**REPORT TO THE SUBDIVISION AND  
DEVELOPMENT APPEAL BOARD**

<b>DATE:</b> <del>April 29, 2021</del> ; July 8, 2021	<b>APPEAL NO.:</b> SDAB2021-0028 <b>FILE NO.:</b> SB2020-0029
<b>APPEAL BY:</b> Deer Trail Development Inc. and Maidment Land Surveys Ltd., represented by Robert Homersham	
<b>FROM A DECISION OF THE SUBDIVISION AUTHORITY</b> where a subdivision  was refused at  <u>882 77 Street SW:</u> <u>PLAN 0210368; BLOCK D; LOT 22</u>	<b>LAND USE DESIGNATION:</b> R-1s
<b>COMMUNITY OF:</b> West Springs	<b>DATE OF DECISION:</b> March 16, 2021
<b>APPLICANTS:</b> Deer Trail Development Inc. and Maidment Land Surveys Ltd., rep. by Robert Homersham	<b>OWNER:</b> Deer Trail Development Inc., represented by Robert Homersham

## Reasons for Refusal – Subdivision by Plan

1 FIRE TRUCK ENTRANCE MOVEMENT  
SCALE 1:500

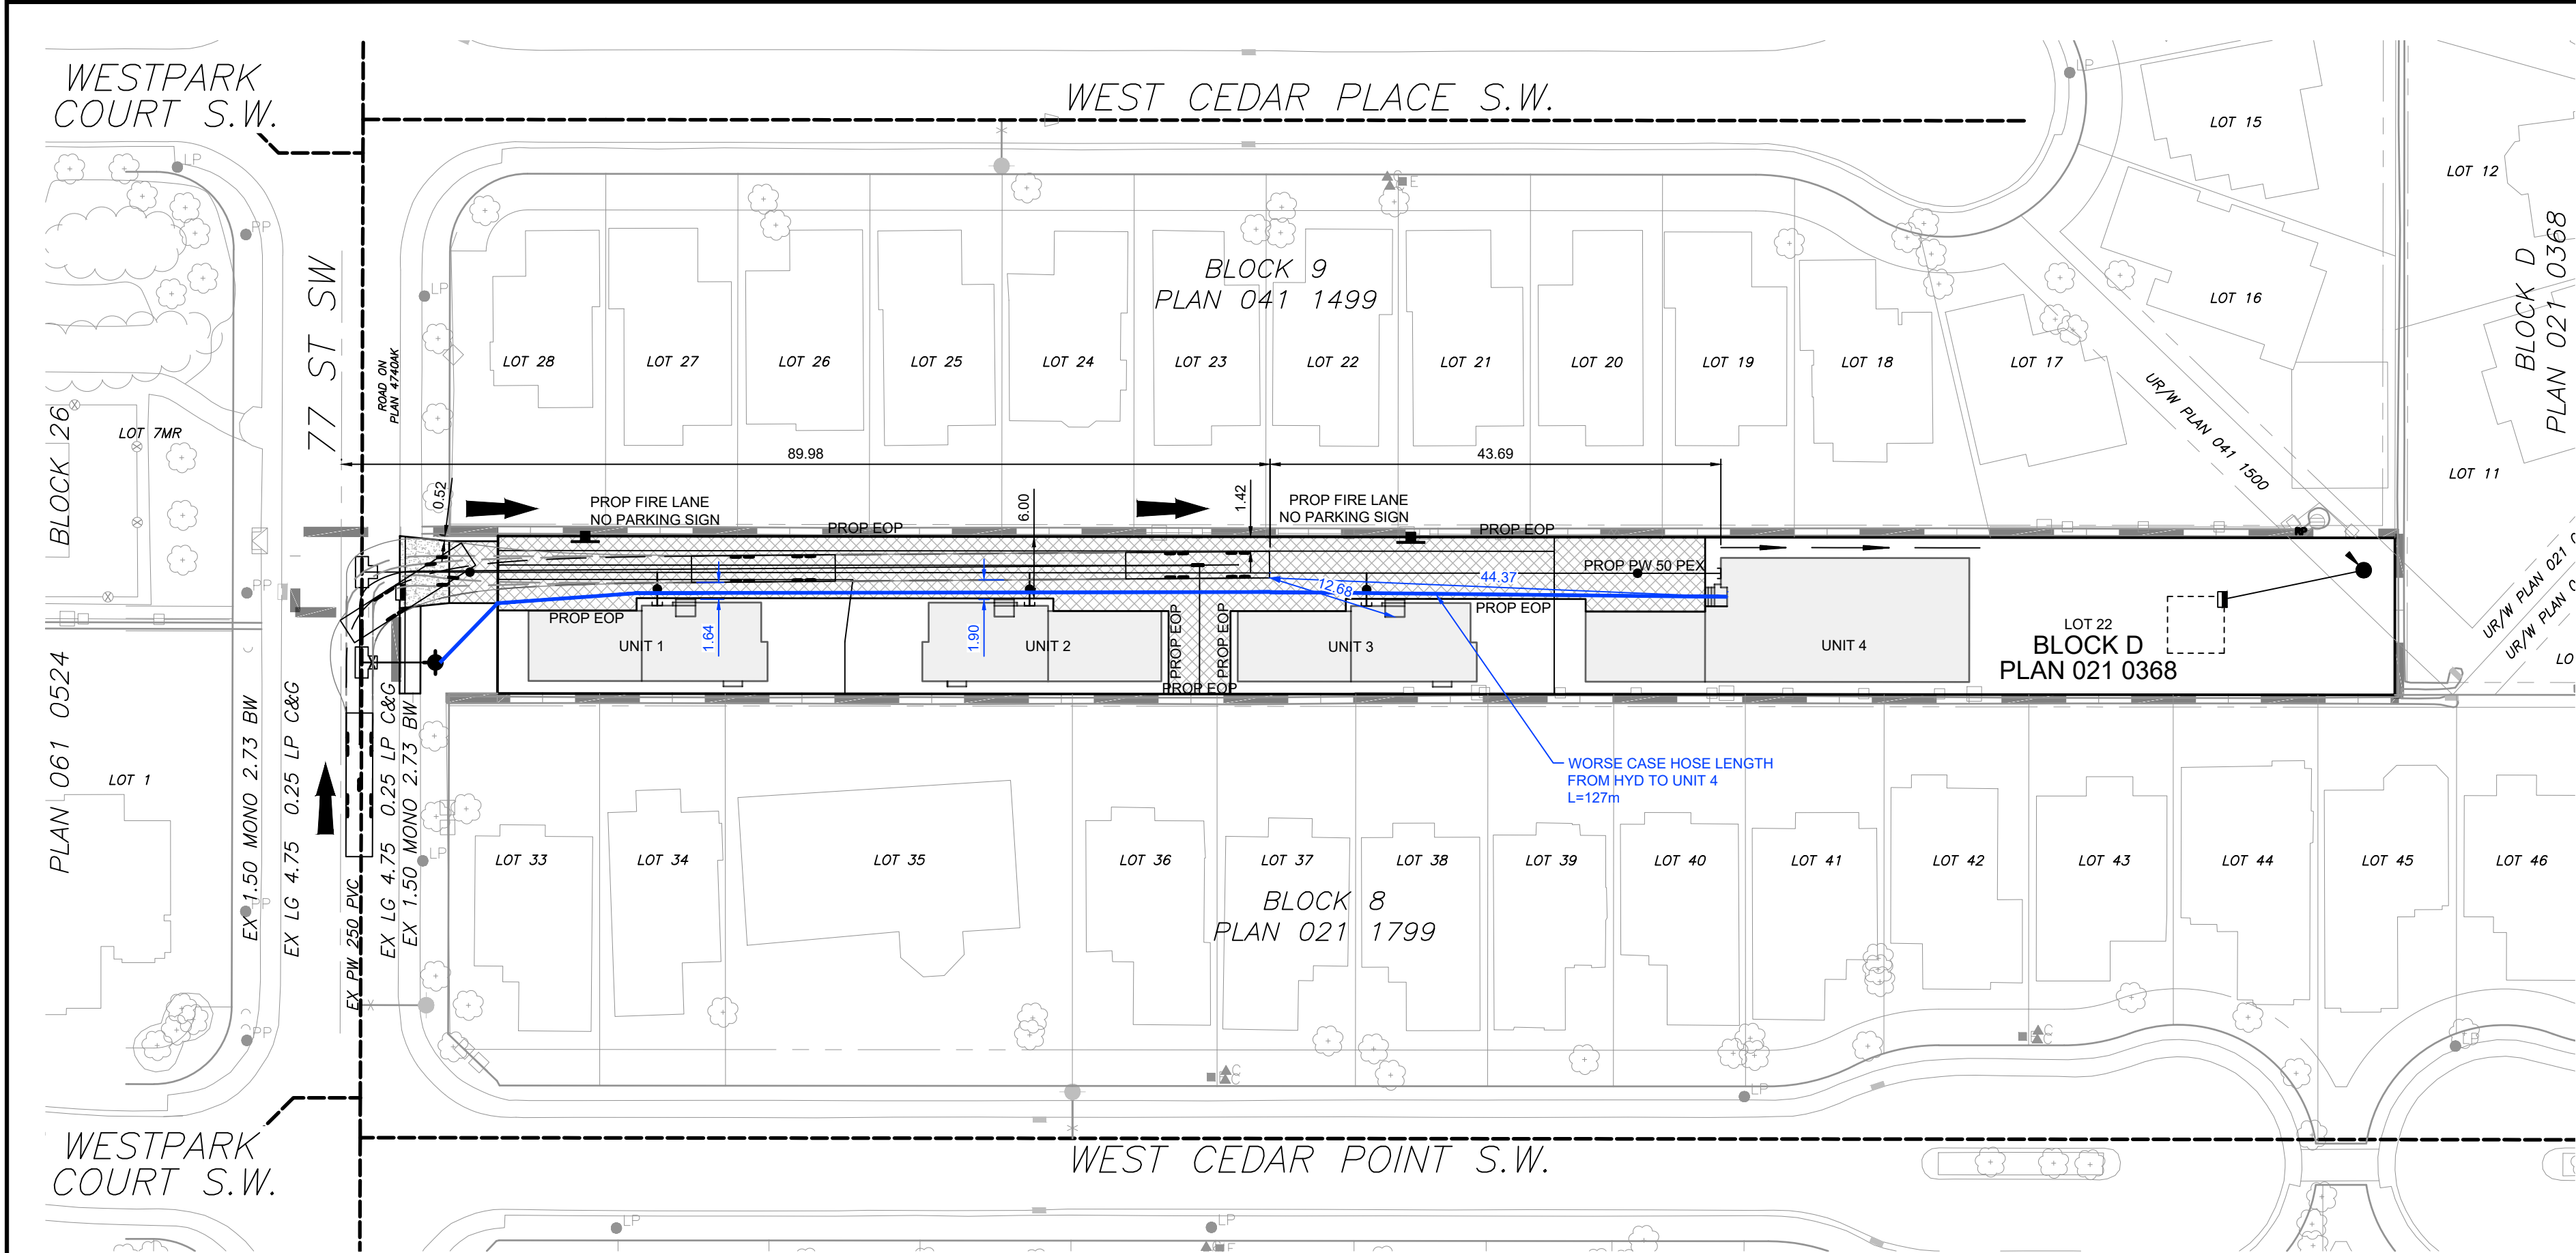
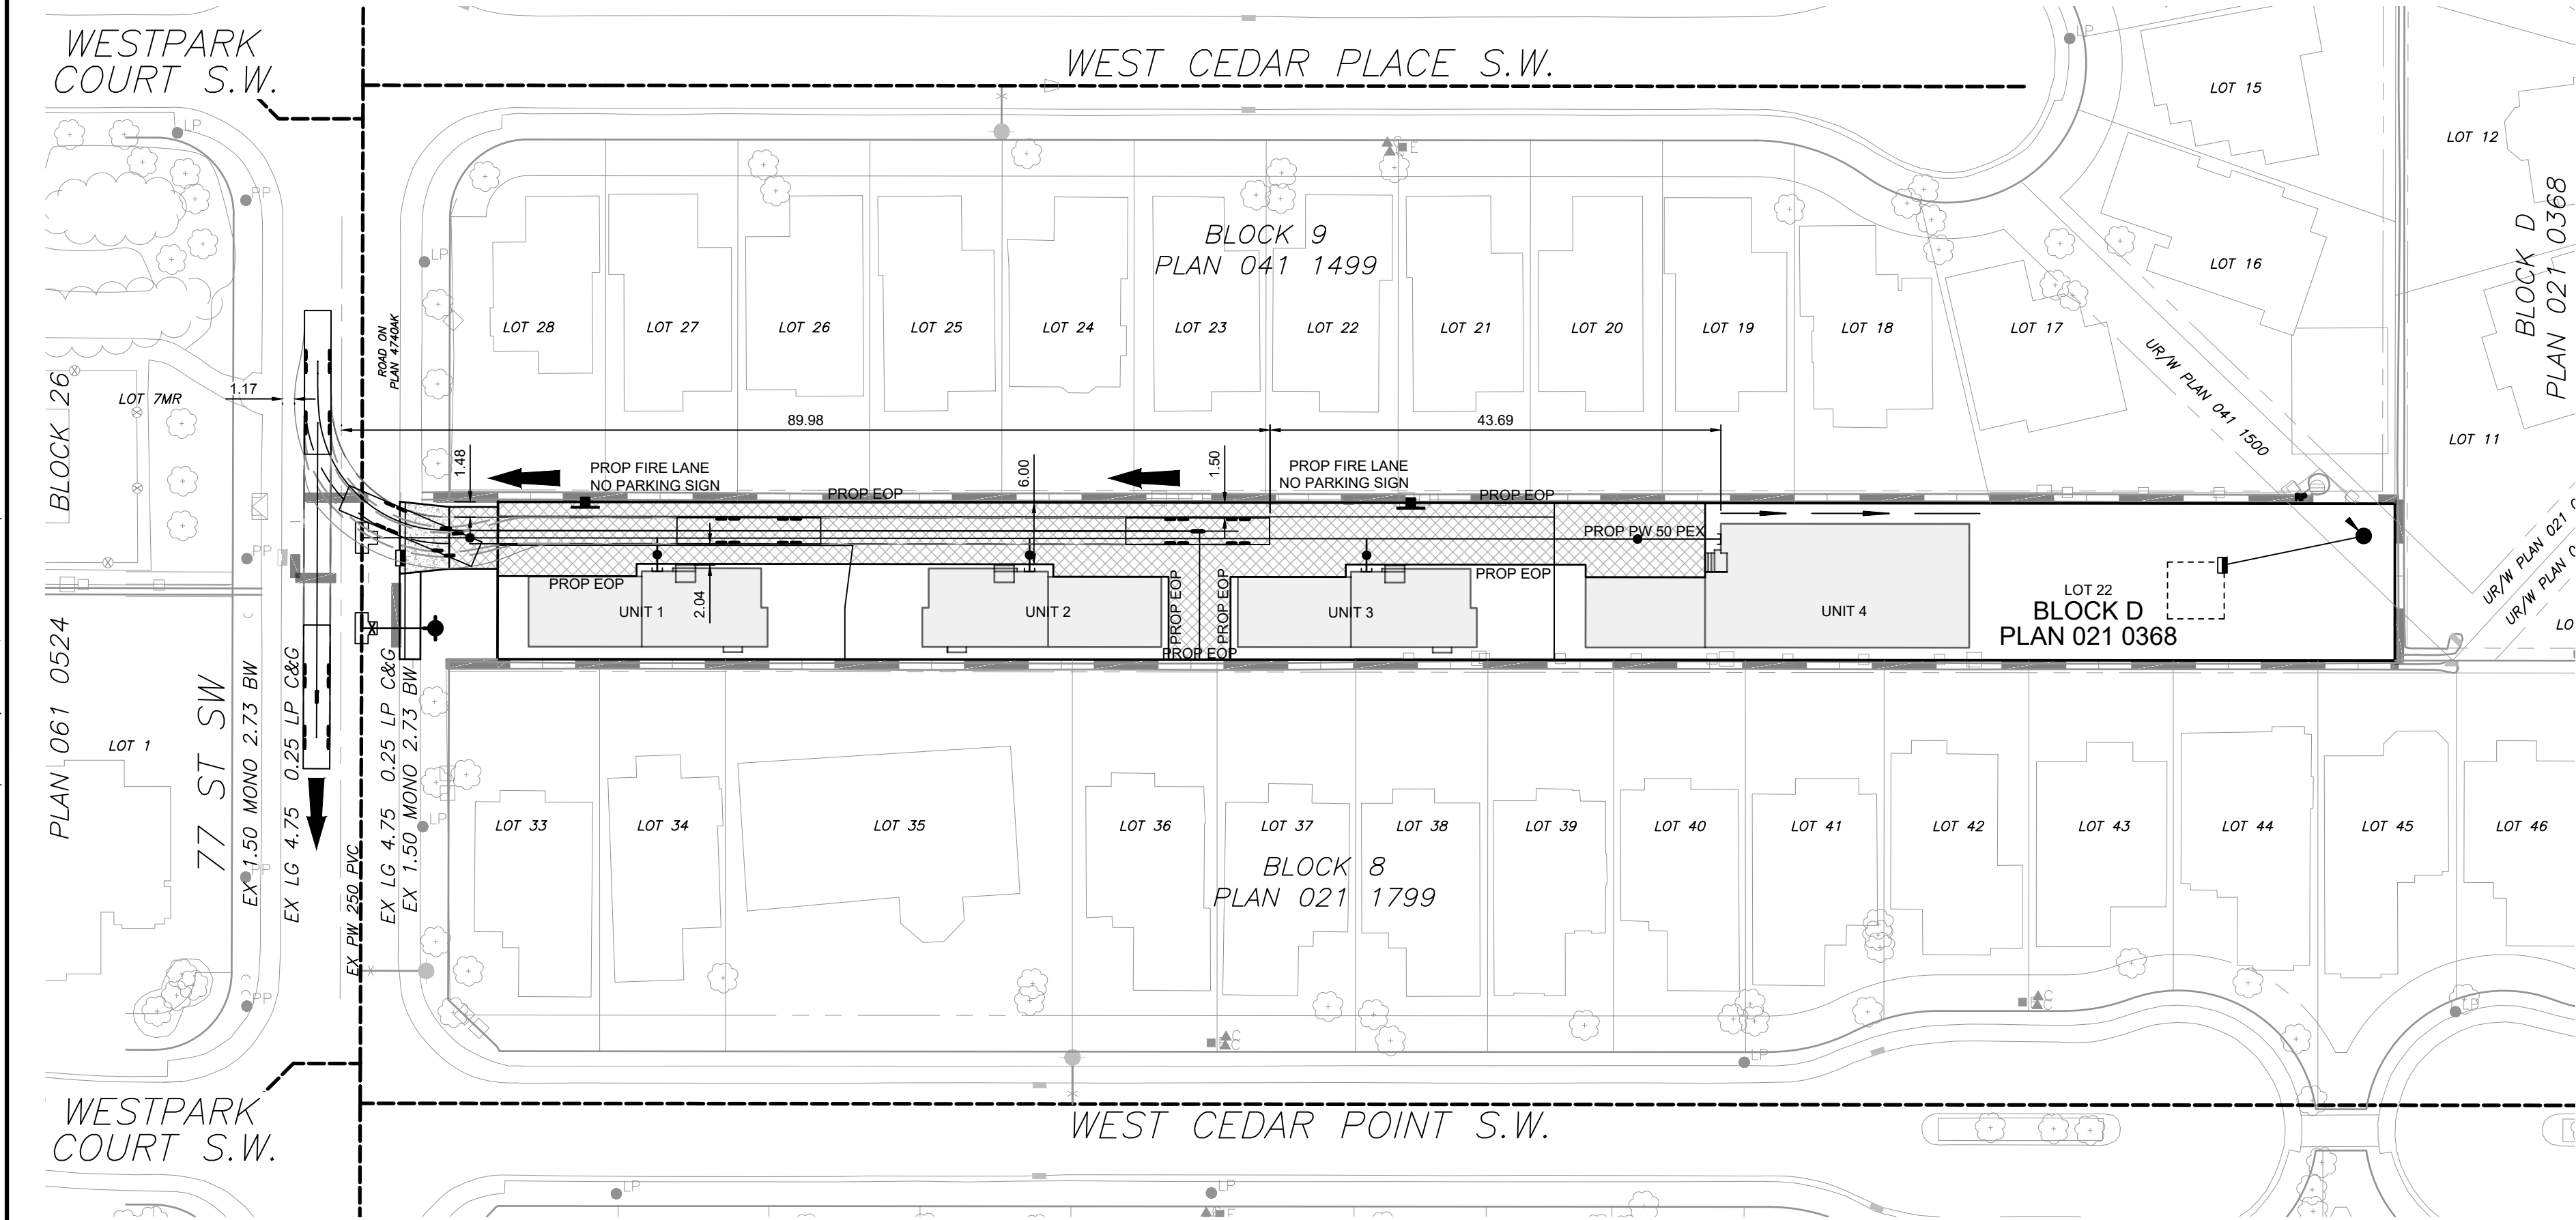
- 2-28 West Park Common
- Singular vehicle access to ~26 Townhome units
- 7.2m access
